October 13, 2015

Kenai Peninsula Assembly Members
Soldotna, Alaska

The propose Keohane land-for-easement swap of Ordinance 2014-32 appears to be ill-considered.

MP 12.1 CONCEPTUAL STORAGE WATER

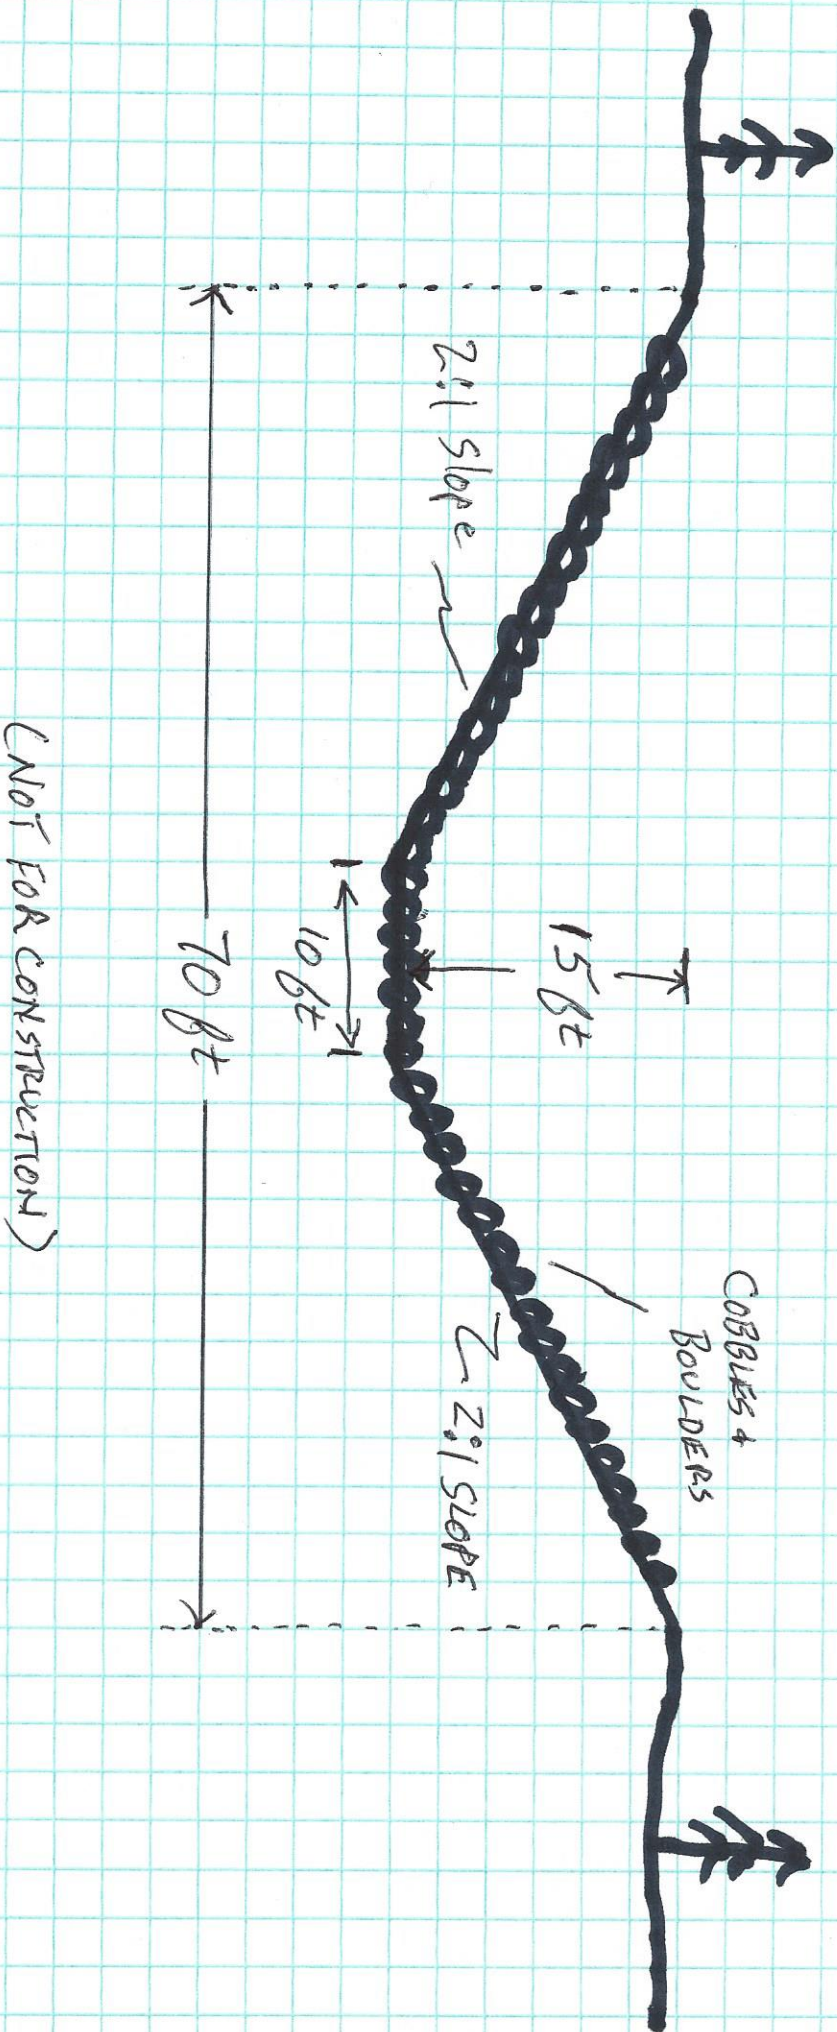
The proposed drainage easement at MP 12.1 is also un-engineered. While the Borough reports verbal communication with DOT&PF suggesting that the proposed 60-foot easement is adequate, I spoke with Jill Reese, a senior administrator at DOT last week, and she was perfectly clear that DOT&PF was not standing behind such an assessment. She said that DOT&PF did not know what would be required for a storm water conveyance structure because the engineering had not been done. For example, I am attaching a conceptual diagram showing a 15-foot-deep armored ditch between K-Beach Road and the Inlet that would require 70 feet or more for the structure alone.

Today, I can't think of a better way for the Borough to increase its liabilities than to sign up for a non-engineered drainage plan. Instead, the Borough should begin engineering a gravity drainage/non-siphon system to get water from the Karluk Avenue road ditch as well as the Buoy Avenue and Trawling Avenue ditches safely to Cook Inlet using the full MP 12.1 parcel, if needed.
